Device Errata

Skywire® Modem

NimbeLink // Products
Published // June, 2015

3 How to Identify PCB Revision

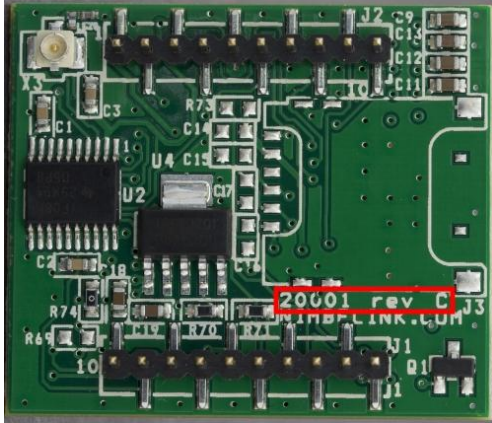
The PCB revision is found on the bottom side of the modem between J1 (Skywire interface connector) and J3 (Micro-SIM socket). The revision is written in white silkscreen and is of the form 20001 rev X.

5 Board Rework

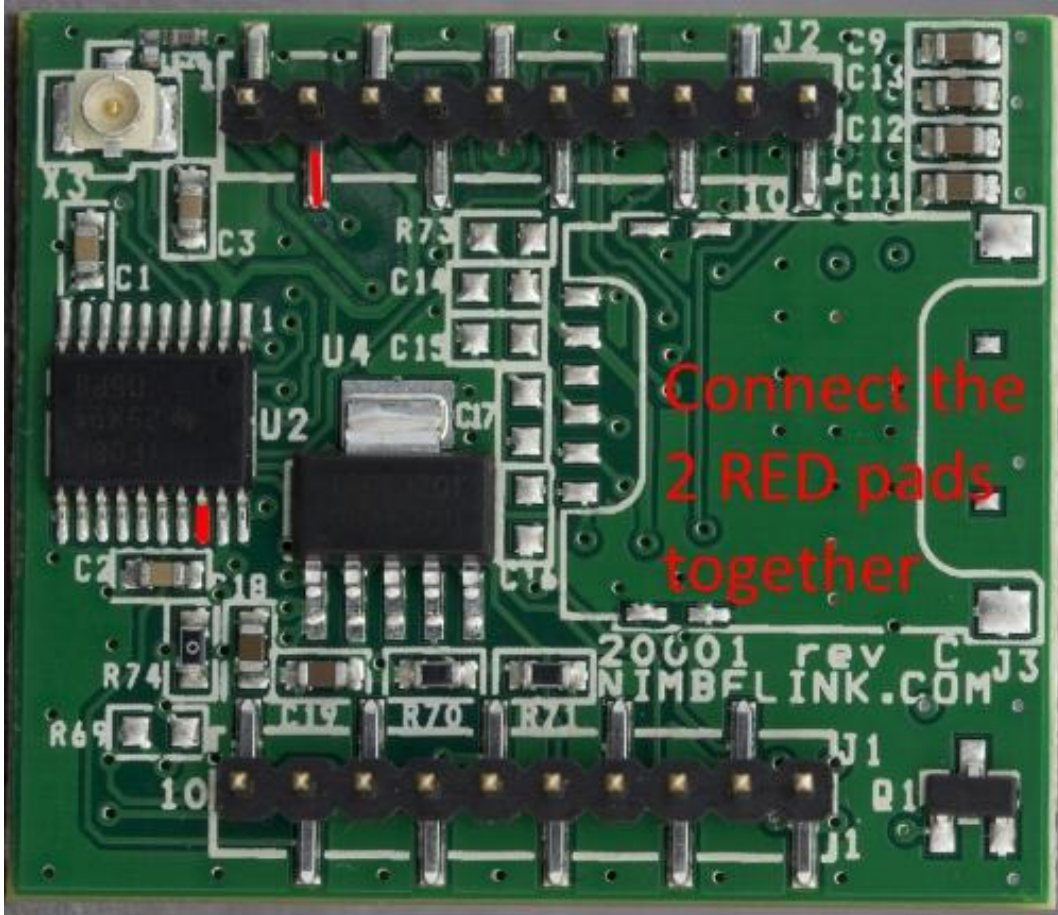
This Errata affects applications requiring use of the UART CTS hardware flow control output from the Skywire modem. The UART CTS signal (Pin 12 on the Skywire interface) is not connected on NimbeLink PCBs prior to PCB revision F. This Errata does not affect your design if any of the following are true:

The Errata can be repaired on affected product by soldering a wire to the underside of the modem. The wire must connect Skywire interface pin 12 to U2 pin 18. Adding this wire will not invalidate the product warranty, however, poor workmanship can damage the modem and invalidate the warranty.
